**ADDENDUM NO. 1**

**CITY OF ABERDEEN**

**NORTHEAST TANK ALTITUDE VALVE VAULT - CONTRACT NO. 21-02**

TITLE  
SITE PLAN

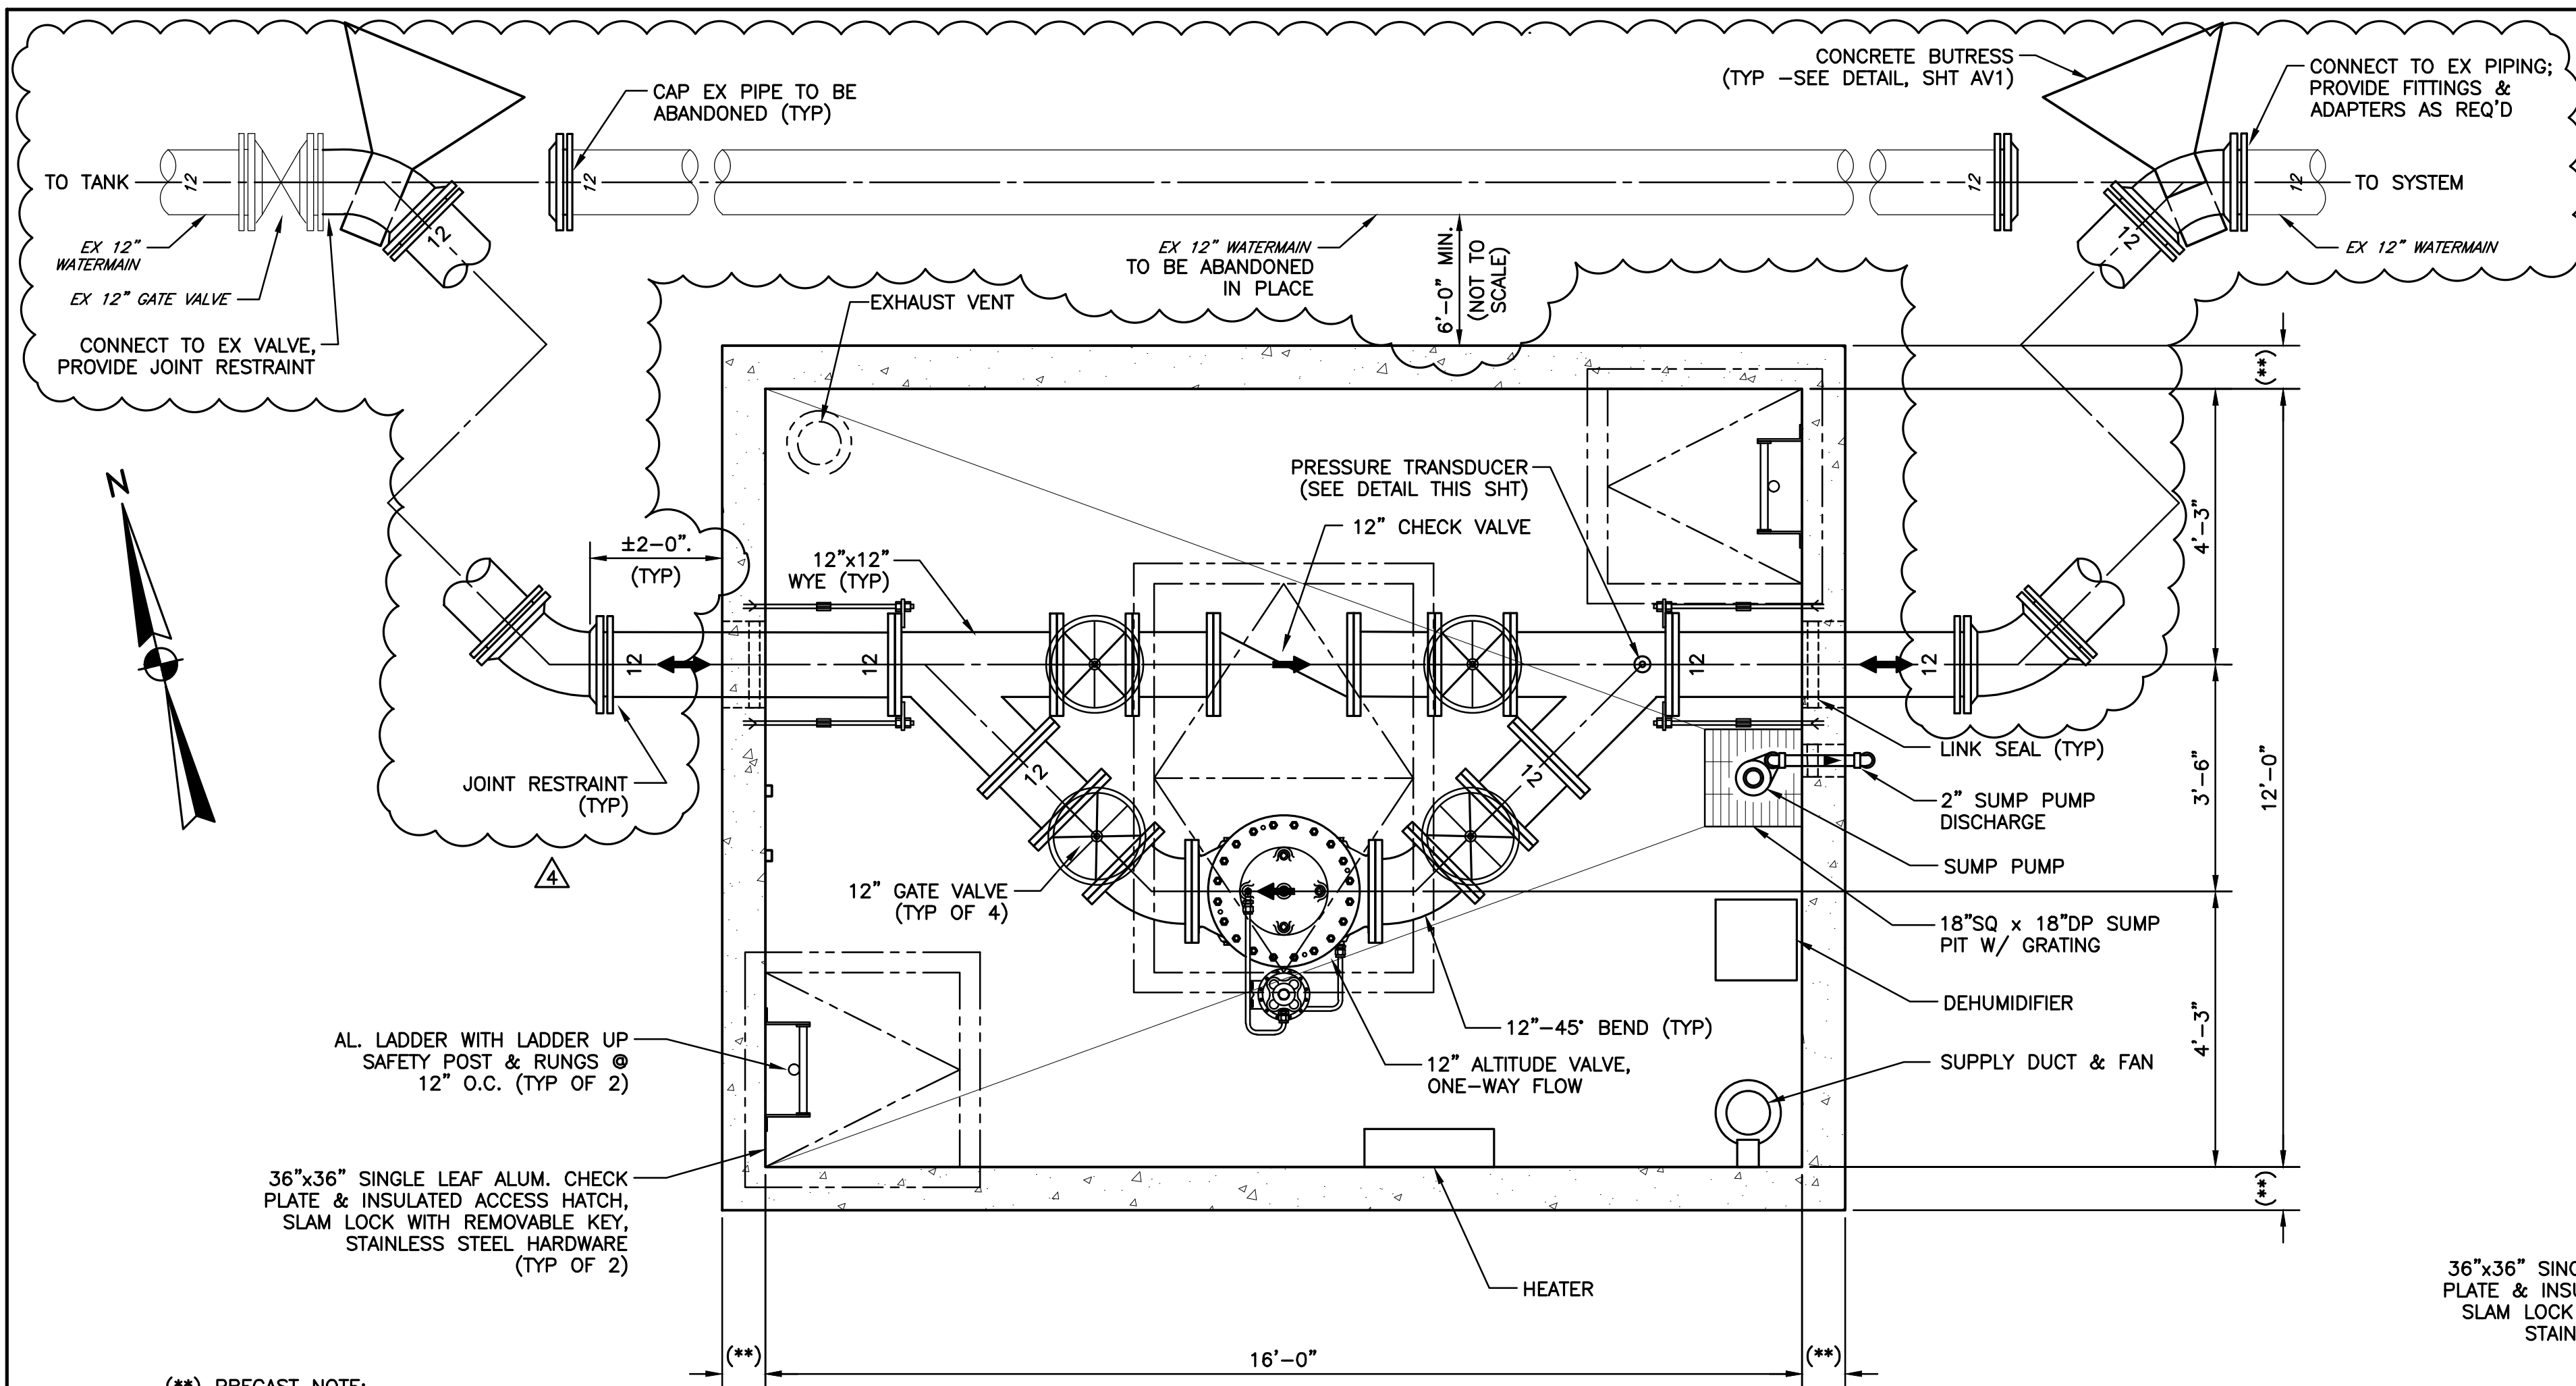
NO	DESCRIPTION	DATE	BY	APP.
4	REVISIONS PER ADDENDUM 1 (REV'D CONNECTION TO EX MAIN)	8/27/20	BTP	JLD
3	ISSUED FOR BIDDING PURPOSES	8/18/20	BTP	JLD
2	90% RESUBMISSION TO CLIENT (SPLIT CONTRACTS)	12/19/19	BTP	JLD
1	60% SUBMISSION TO CLIENT	7/26/18	BTP	JLD
NO	REVISIONS
